RE: Family Farm & Home-Special Land Use and Site Plan re-submittal

**Family Farm & Home
Planning Commission Meeting 2/12/18
Planning Commission Discussion Notes:**

Family Farm & Home Interior Renovation

Family Farm and Home Interior Renovation

Enlarged Elevation at Fence Pier

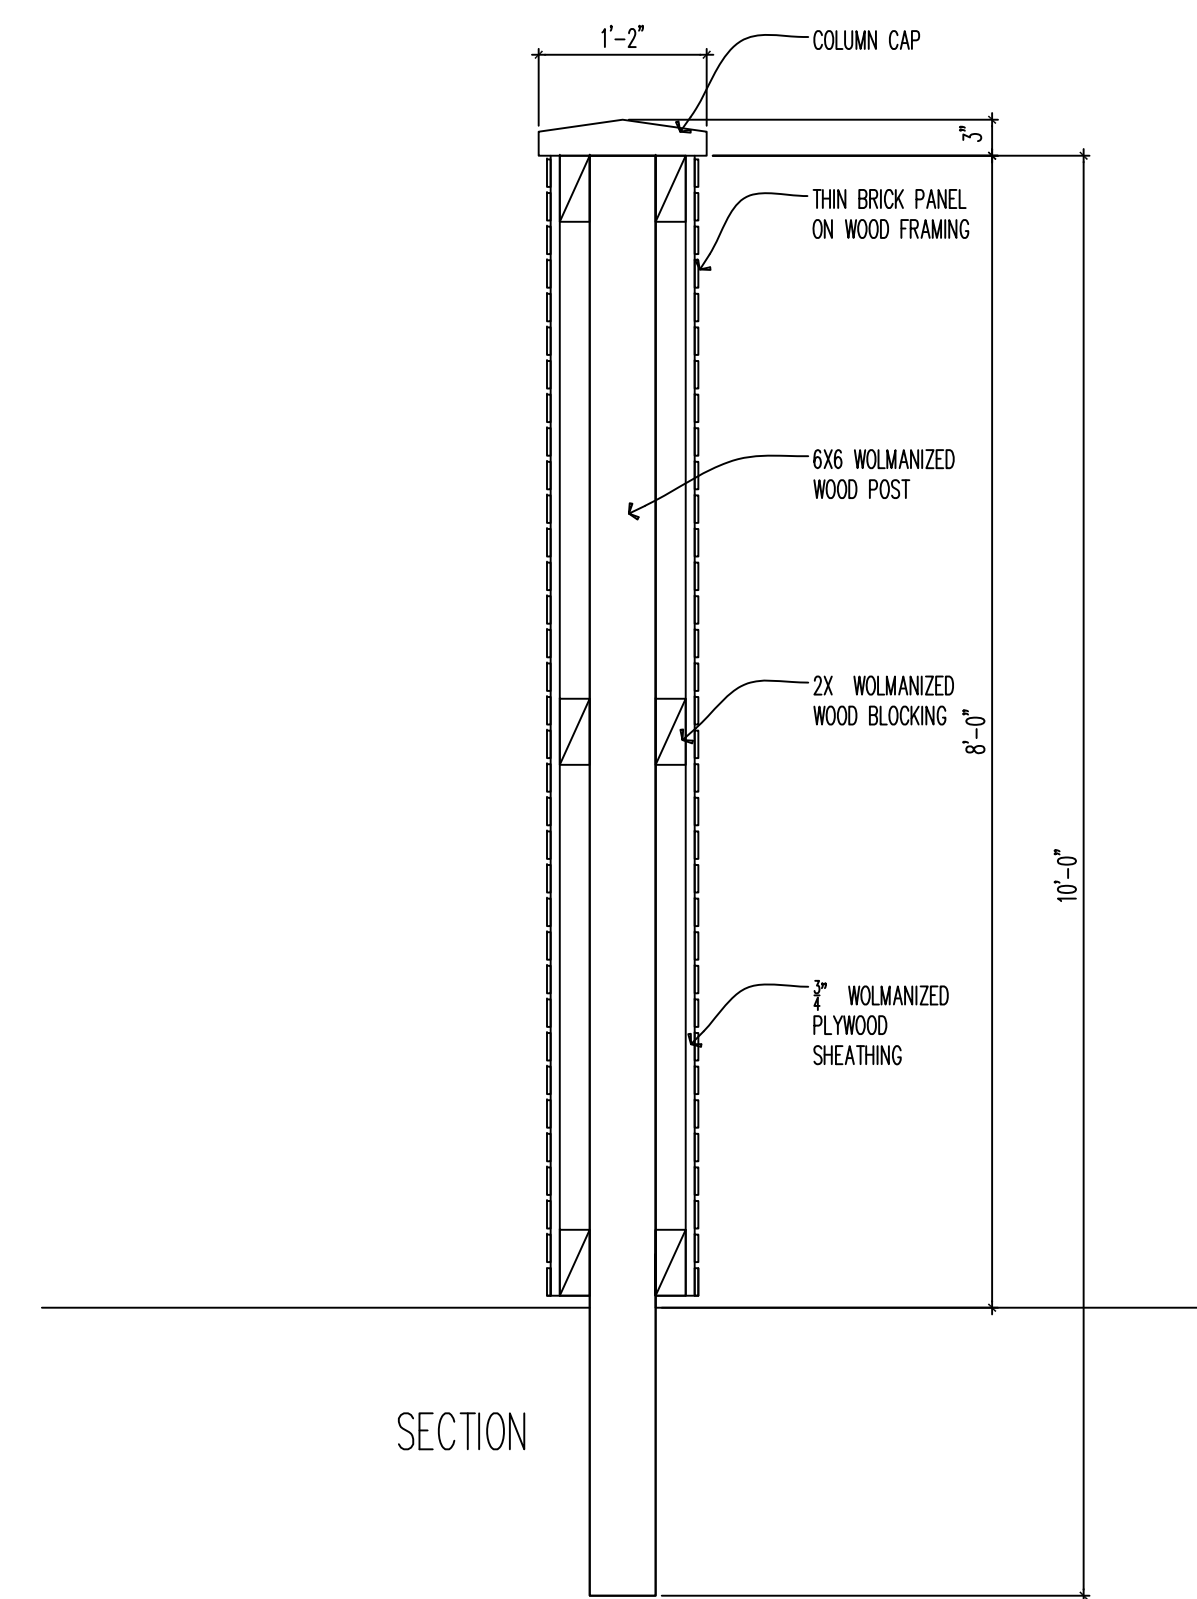
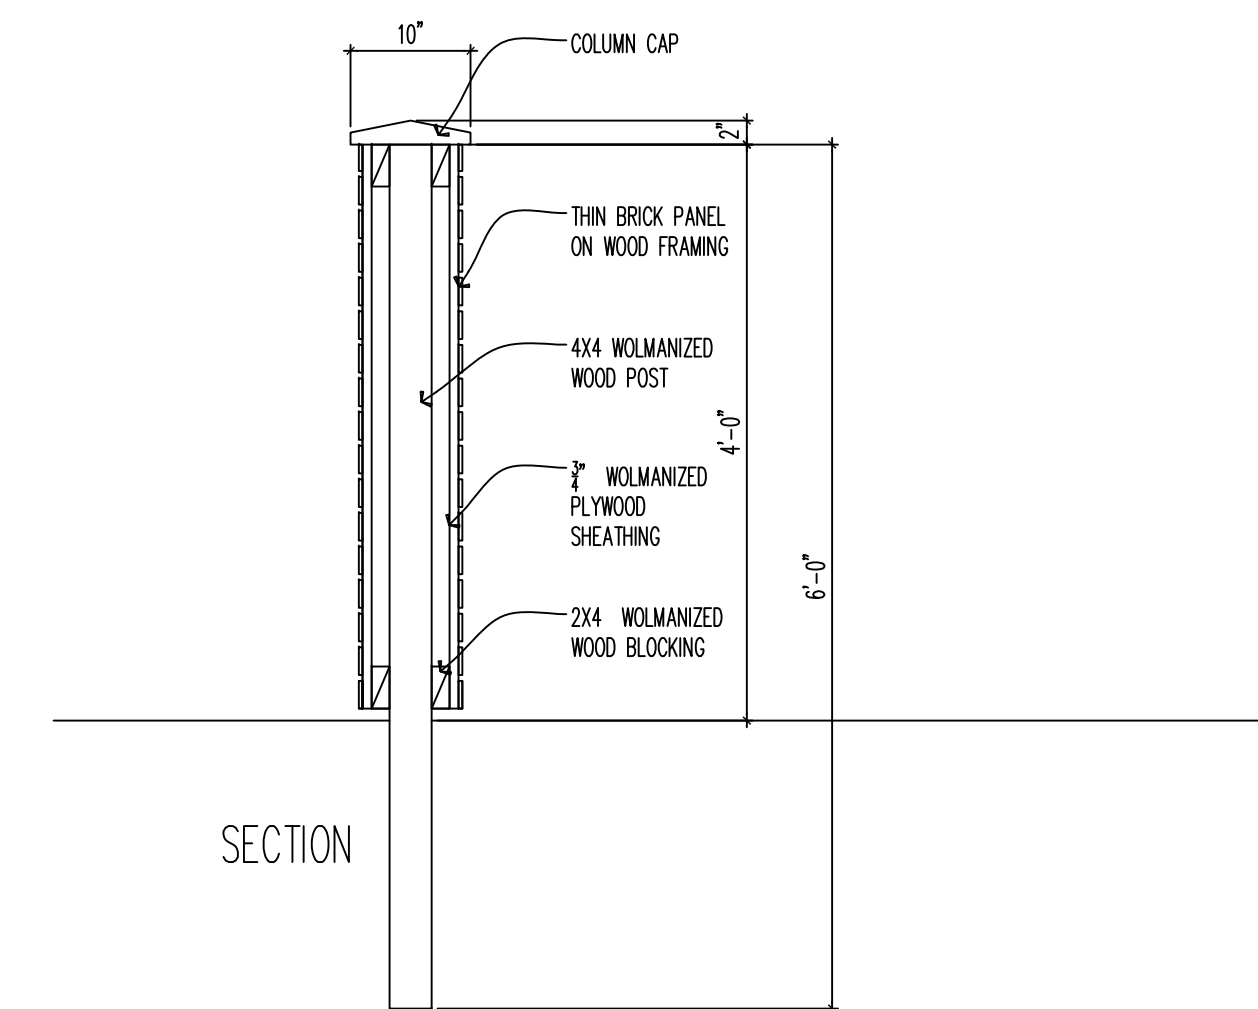
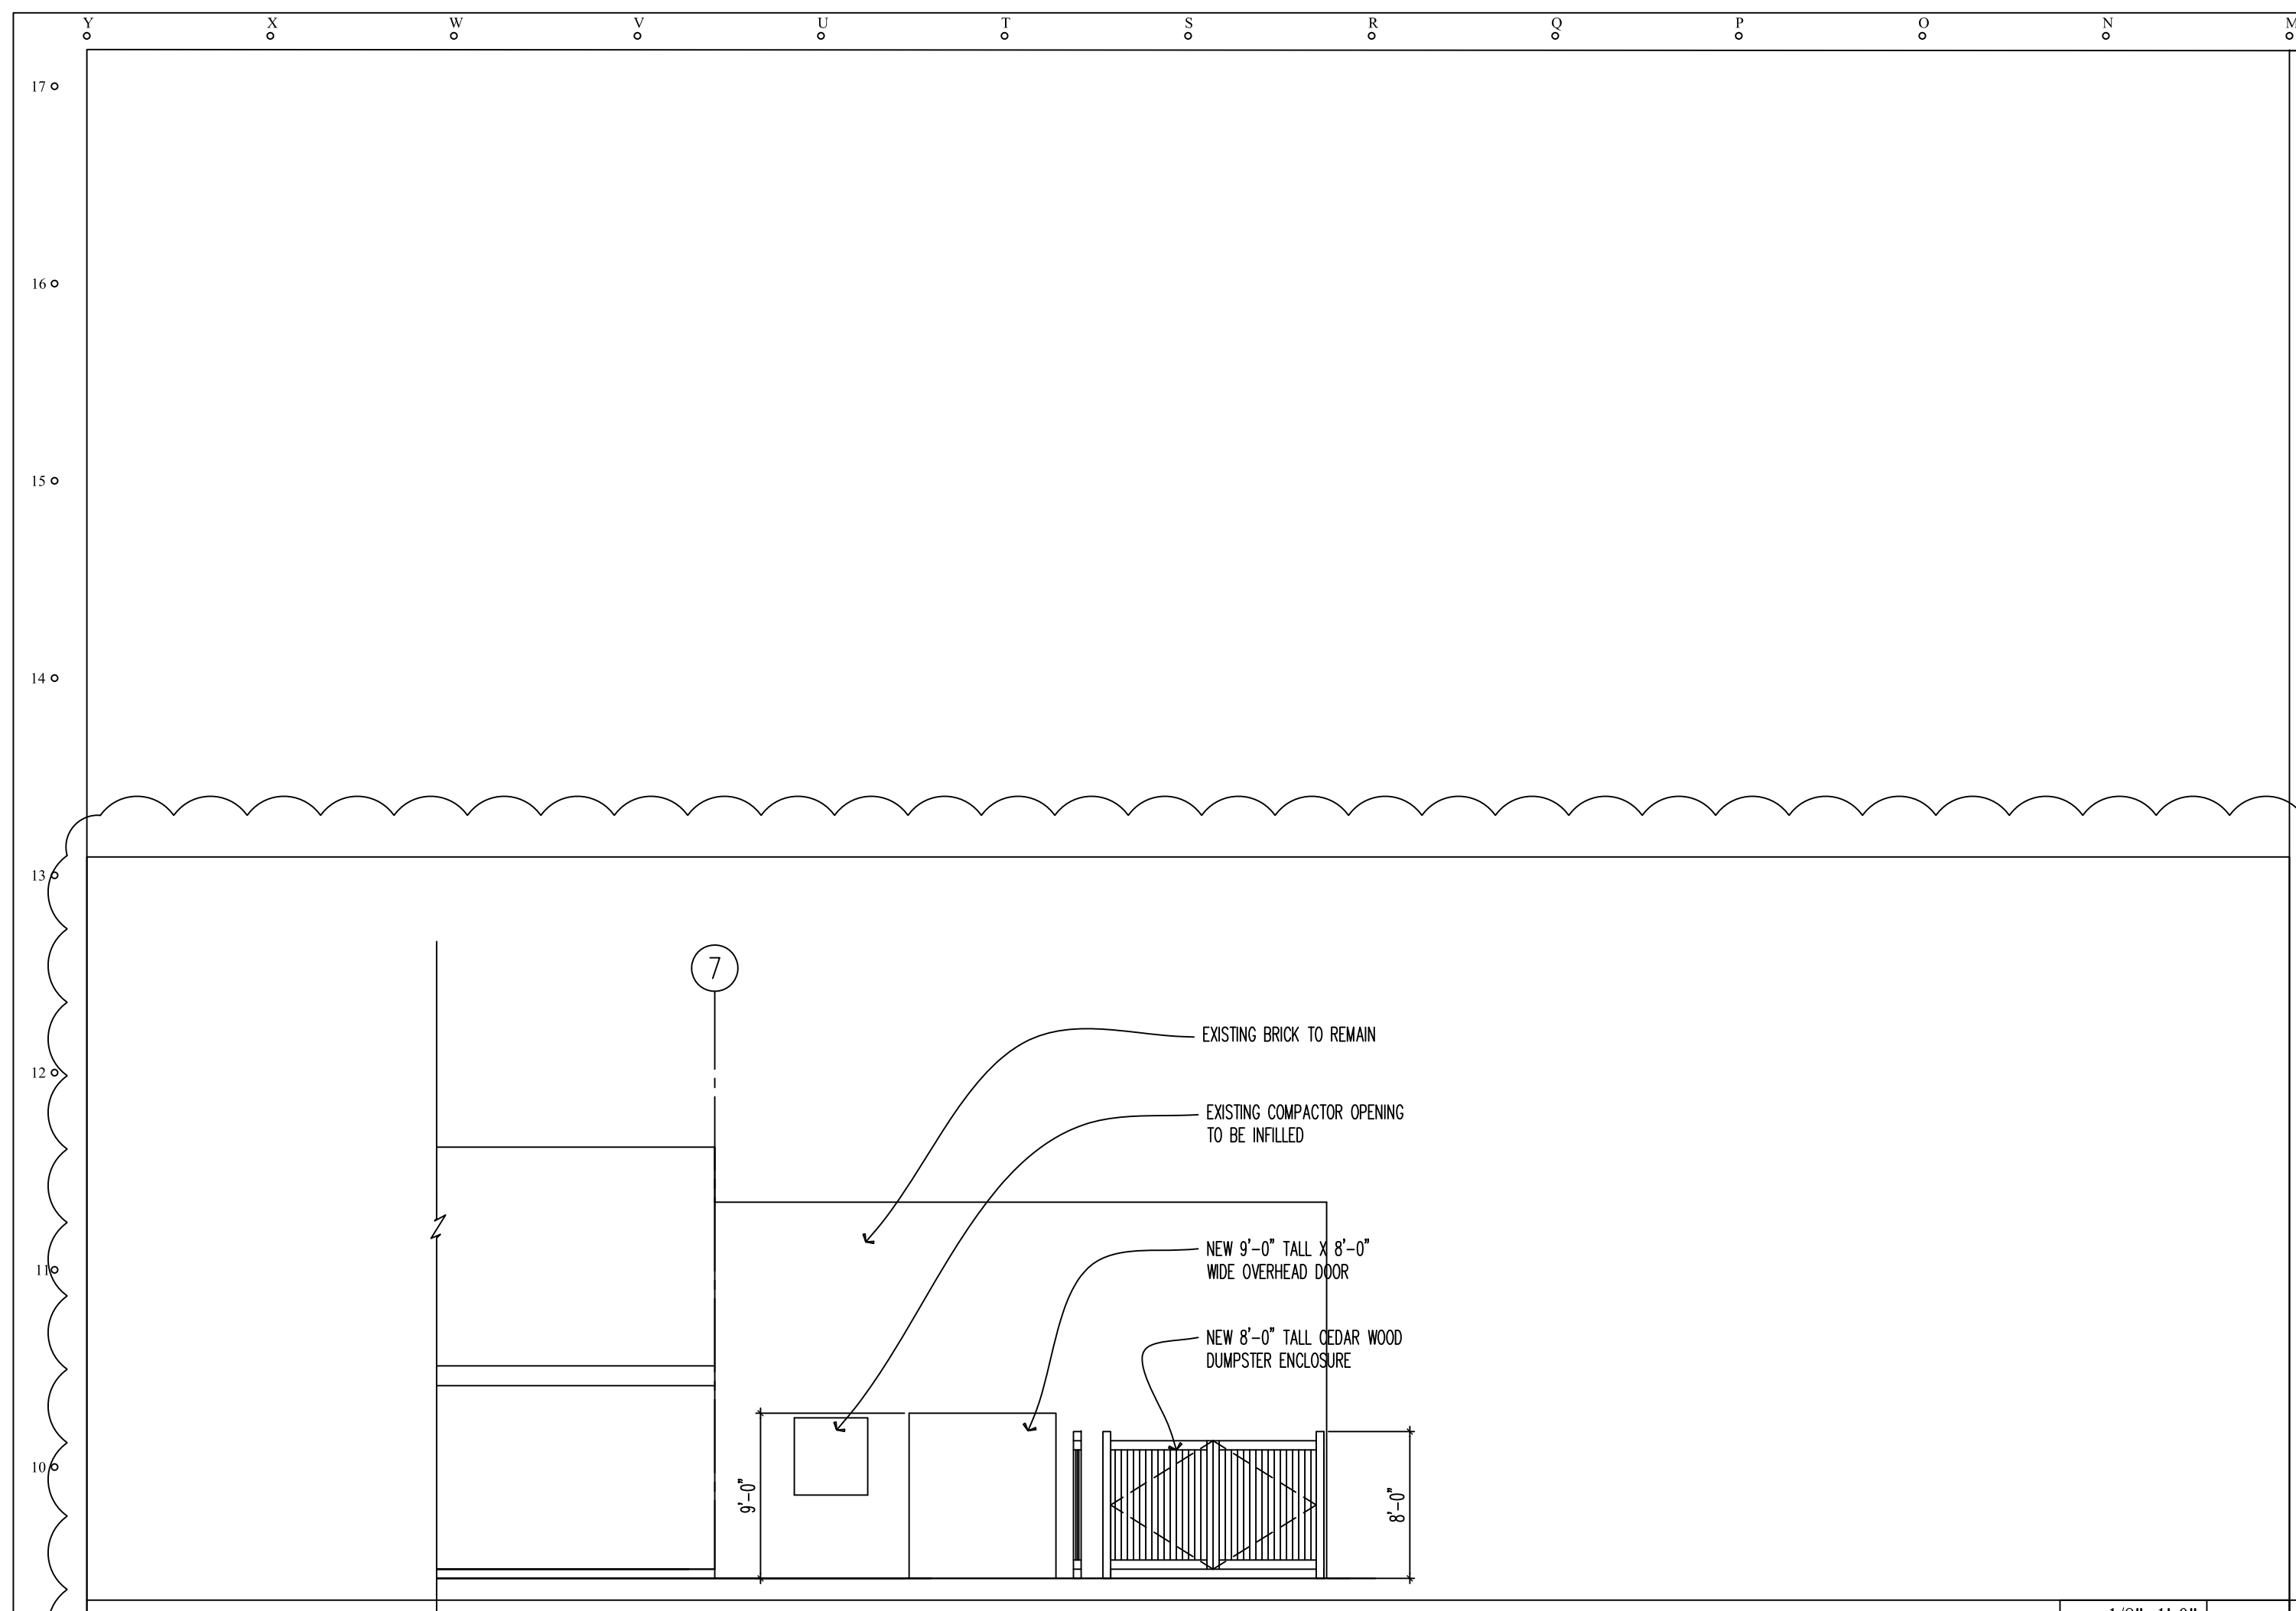
- 1) Staging Area
 - a. Screening
 - b. Fence – PC wants to change material, they want masonry piers
 - c. Plans to be consistent
 - i. Landscape
 - ii. Grassy areas

We added thin brick masonry piers to both sidewalk display and outside storage area,
